EH3500AC2
Rear Strut.

Frame Suspension

Mine Name	File No.	Operator	Activity Type	Region	Activity Date
Middlemount Mine	1762	Middlemount Mine Management Pty Ltd ABN: 62 140 398 143	Inspection - Weekend or Backshift	Central	20/06/2013

Mine Record Entry

Helium Gas/Neocon Oil Charging Procedure Diagram

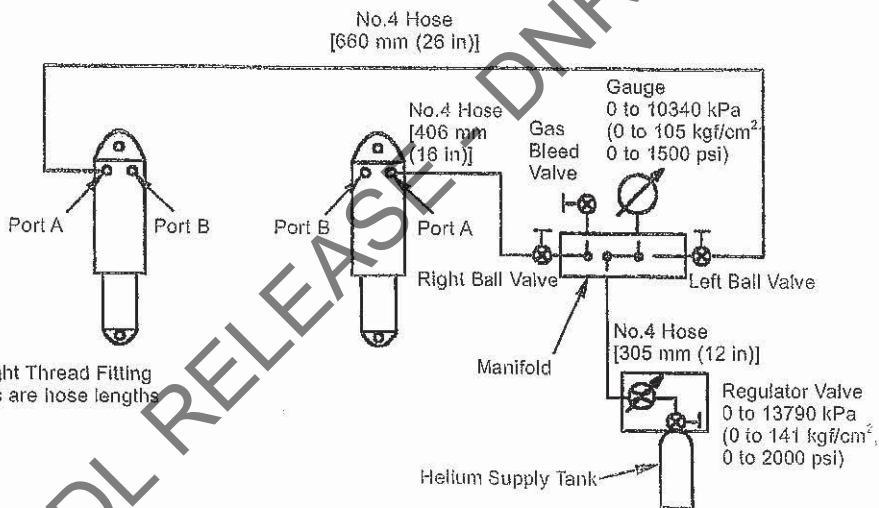
- P-1A conversion from MPa to psi incorrect

- P-1A spec incorrect

Mpa 0.77 should be 0.97 MPa
pg W2-11-34

incorrect conversion
which is correct?

W2-11-37

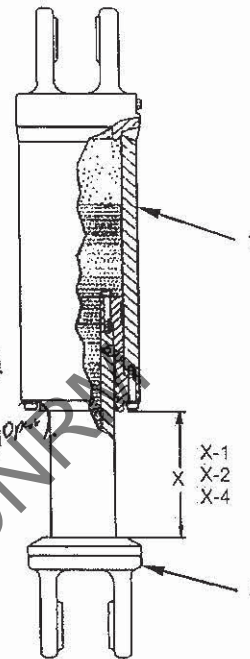
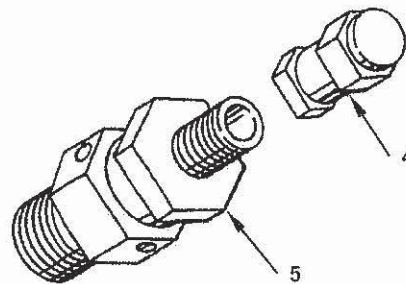
- Step 6 has incorrect spec pressure
not 5.88 Mpa but 1.66 MPa.
pg W2-11-38
